From: <Terrill.Garland@kidde-fenwal.com>  
To: "Jonathan Rivera" <JXR4@nrc.gov>  
Date: 3/25/05 3:54PM  
Subject: Re: SSD review for new Model No. 7054, Certificate No. NR-668-D-101-E

Deficiency Issues To Address / Clarifications Needed  
Kidde Fenwal, 04-58, NR-688-D-101-E

No.	DATE	DESCRIPTION	REV.	CHK.	APP.	TITLE:
						IONIZATION SMOKE DETECTOR
UNIT: mm			SCALE: 1 / 1	7051 DETECTOR ASSEMBLY		
DATE: SEP. 25 2002			DVG. NO. AF30404000			
DESIGNED BY: A. Okada			TRACED BY:			
CHECKED BY: J. Yokihama			APPROVED BY: [Signature]			
NOHMI BOSAI LTD.

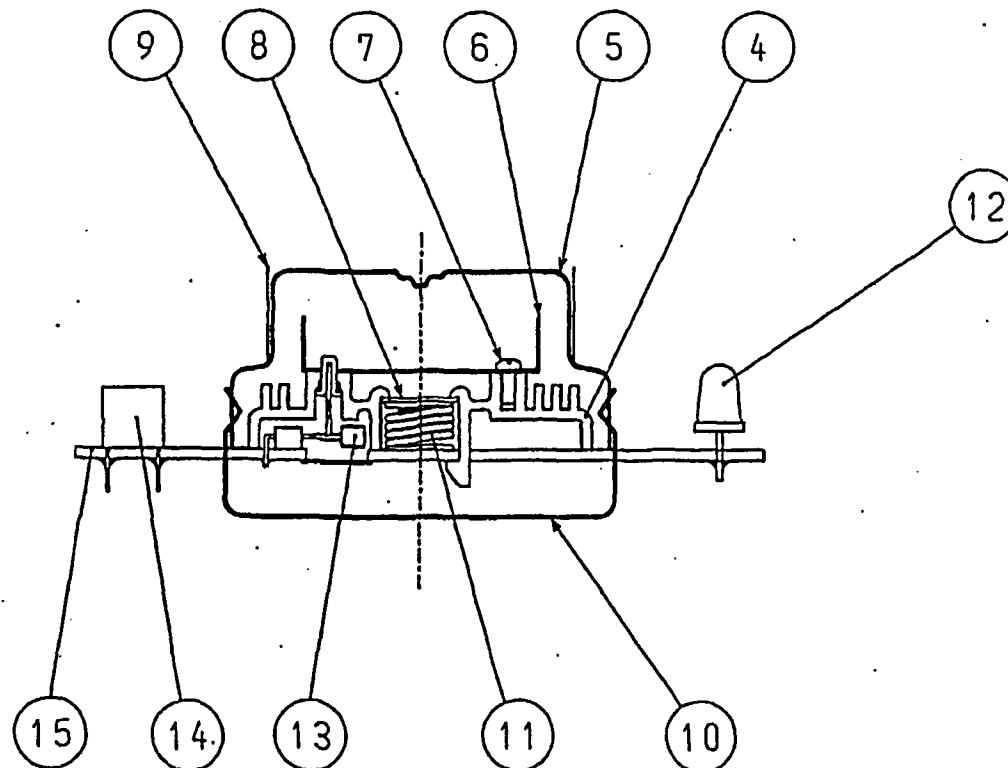
In your application, under the Detector Assembly drawing, Appendix B, you indicate screws under Item Nos. 15 and 16. Please indicate whether or not these screws are tamper resistant, and/or describe how access to the source is prevented.

(These are standard screws, which only hold on the plastic enclosure. The steel Outer Chamber, item No.5, which is soldered to the PC bd., prevents access to the source.)
